**AMENDMENTS TO THE DRAWINGS**

The originally filed U.S. national stage application Serial No. 10/530,804 included in the drawings, inter alia, “PCT SUBSTITUTE SHEET (RULE 26)” 5/17, “PCT SUBSTITUTE SHEET (RULE 26)” 6/17, and “PCT SUBSTITUTE SHEET (RULE 26)” 7/17.

5/17

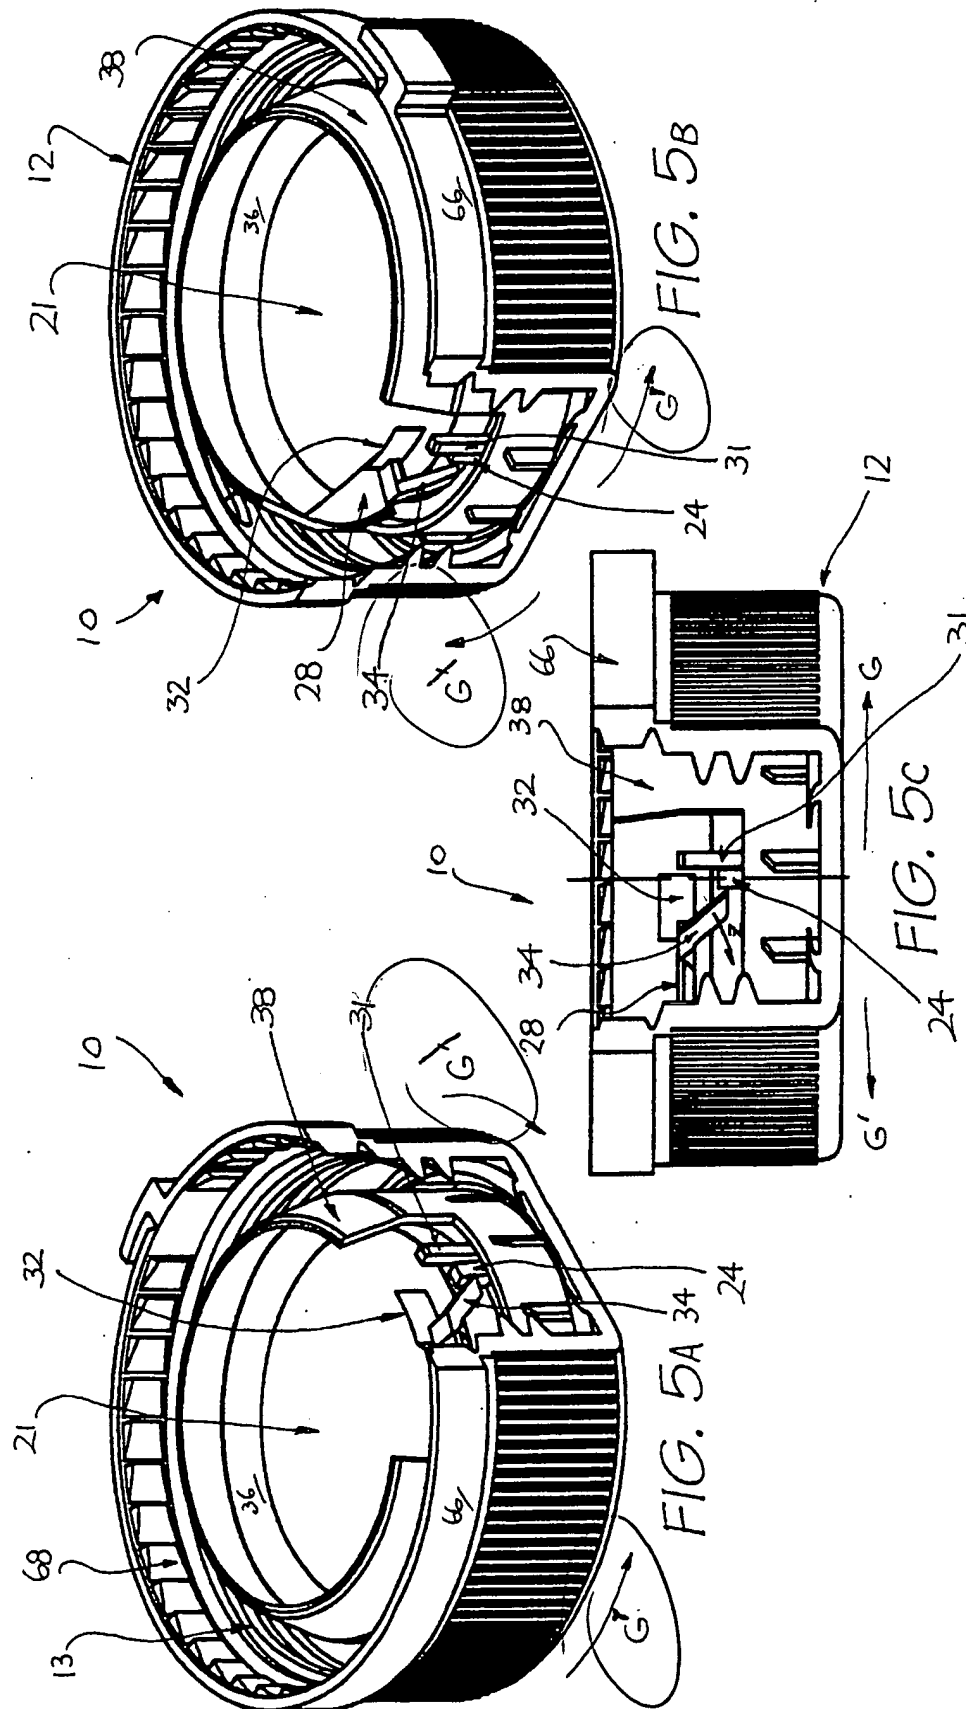
Pursuant to 37 C.F.R. 1.121(d)(1), presented in this amendment section after this page 4 are copies of the above-captioned instant patent application drawing “PCT SUBSTITUTE SHEET (RULE 26)” sheets 5/17, 6/17, and 7/17 which each has been labeled “ANNOTATED SHEET” and marked in red on FIGS. 5A, 5B, 5C, 6A, and 7A to show a proposed correction which interchanges the rotation arrow designations G and G’ for lid rotation.

The proposed correction does not add new matter because the proper operation of the screwing on and off rotation directions represented by the arrows was correctly described in the specification as originally filed and was properly shown in the originally filed drawing FIGS. 10 and 13.

Also, pursuant to 37 C.F.R. 1.121(d), attached at the end of this CORRECTED RESPONSE AND AMENDMENT document are amended copies of the originally filed PCT SUBSTITUTE SHEET (RULE 26) sheets 5/17, 6/17, and 7/17 incorporating the above-discussed drawing correction, and each such sheet is labeled in the top margin as “Replacement Sheet.”
